Flowpack Calculator — Old vs New Calculation

Change: +1 click per kg of candy foil (new candy type) + 5 safety clicks | Generated June 11, 2026

Mode: "3 ens FP" (same design on all 3 lanes)

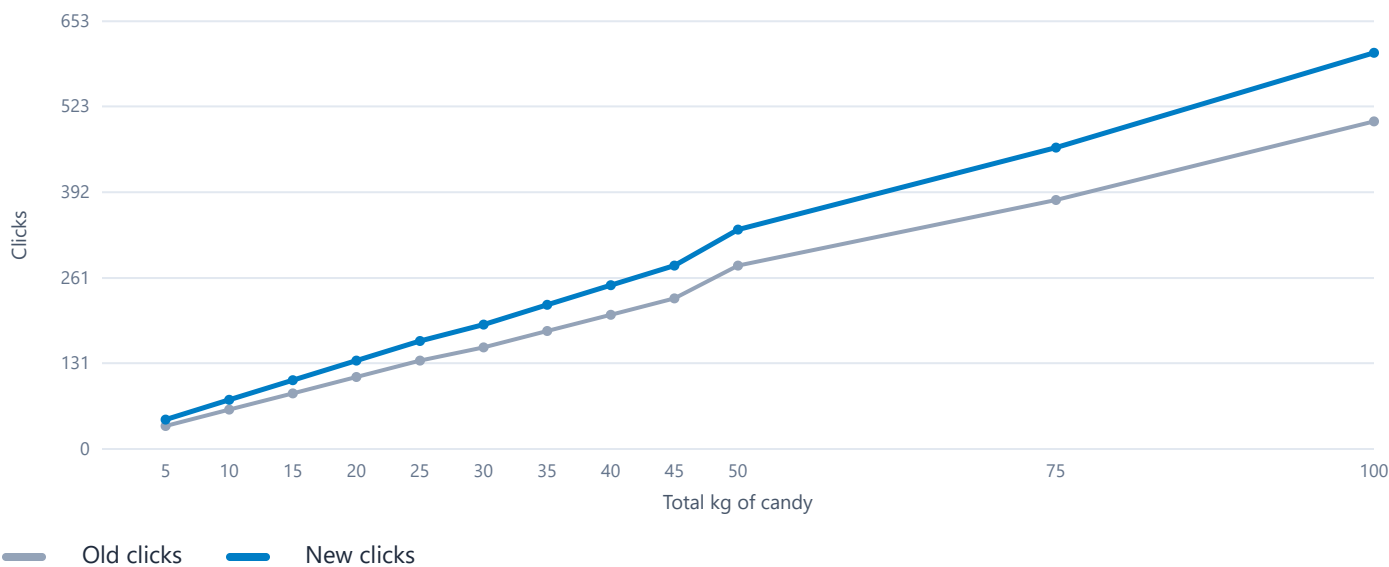
OLD formula

```
clicks = ceil( baseClicks )
meters = round( clicks × m/click ÷ 5 ) × 5
```

NEW formula

```
clicks = ceil( baseClicks + totalKg × 1 + 5 )
meters = round( clicks × m/click ÷ 5 ) × 5
```

Mode: "1 FP pr lane" (mix mode — table lookup at totalKg ÷ 3)

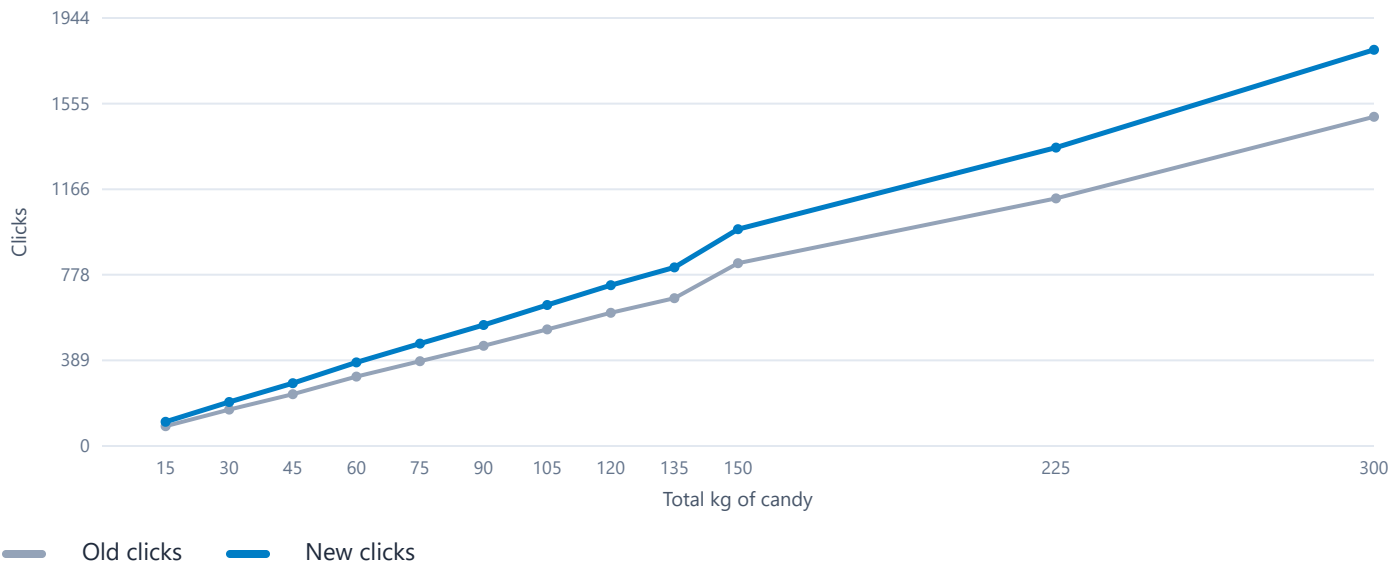
In "1 FP pr lane" mode the interpolation table is looked up at totalKg ÷ 3, while the extra clicks are based on the full total kg.
